Access Compliance Report

Public Rights-of-Way

(Curb Ramps)

Intersection ID: 31601	Main Street: BULL_RUN_RD	Cross Street: GETALONG_RD	Location: SE
ADA ID: AC18A3ECA713	Ramp Type: Perp	Initial Pass/Fail: Pass	Overall Compliance: No
		Severity Score: 15

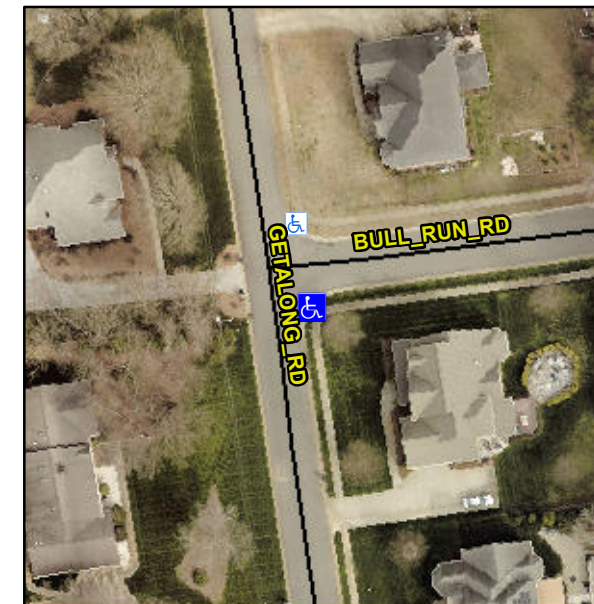
Not Found, R304.2.2-Perp, R304.3.2-Para, R302.7.2

Compliance	Description	Data	Compliance	Description	Data
N/A	Ramp Length (in)	47.0	Yes	Ramp Slope (%)	7.5
Yes	Ramp Width (in)	48.0	Yes	Ramp XSlope (%)	0.6
N/A	Flare Type LT	Sloped	N/A	Flare Type RT	N/A
N/A	Flare Slope LT (%)	5.2	N/A	Flare Slope RT (%)	5.8
N/A	Flare Traversable LT?	No	N/A	Flare Traversable RT?	No
Yes	Landing Length (in)	48.0	Yes	DWS Provided?	Yes
Yes	Landing Width (in)	48.0	Yes	DWS Contrast?	Yes
No	Landing Slope (%)	3.8	Yes	DWS Length (in)	24.0
Yes	Landing X Slope (%)	0.4	Yes	DWS Full Width?	Yes
N/A	Landing Curb? (Y/N)	No	Yes	DWS Offset (in)	1.3
N/A	Shared Landing?	No			
Yes	Gutter Ponding?	No	Yes	Gutter Slope (%)	2.1
No	Gutter Lip Ht (in)	1.0	Yes	Gutter X Slope (%)	0.7
N/A	Painted X Walk1?	No	N/A	Painted X Walk2?	N/A
	X Walk 1 Direction	To N		X Walk 2 Direction	N/A
N/A	X Walk 1 Width (in)	N/A	N/A	X Walk 2 Width (in)	N/A
	X Walk 1 Slope (%)	1.4		X Walk 2 Slope (%)	N/A
	X Walk 1 X Slope (%)	2.1		X Walk 2 X Slope (%)	N/A

N/A	Ramp inside XWalk1?	N/A	N/A	Ramp inside XWalk2?	N/A
	Road Slope (%)	N/A	N/A	Clear Space?	Yes
	Road X Slope (%)	N/A	N/A	Clear Space to XWalk (in)	N/A
Yes	Any Obstructions?	No	Yes	Storm Grate/Utility Hazard?	No
	Obstruction Type			Storm Grate/Utility Type	
		N/A			N/A
			Yes	Surface Condition? (G/P)	Good

Possible Solutions:

Remove & Replace Entire Ramp.
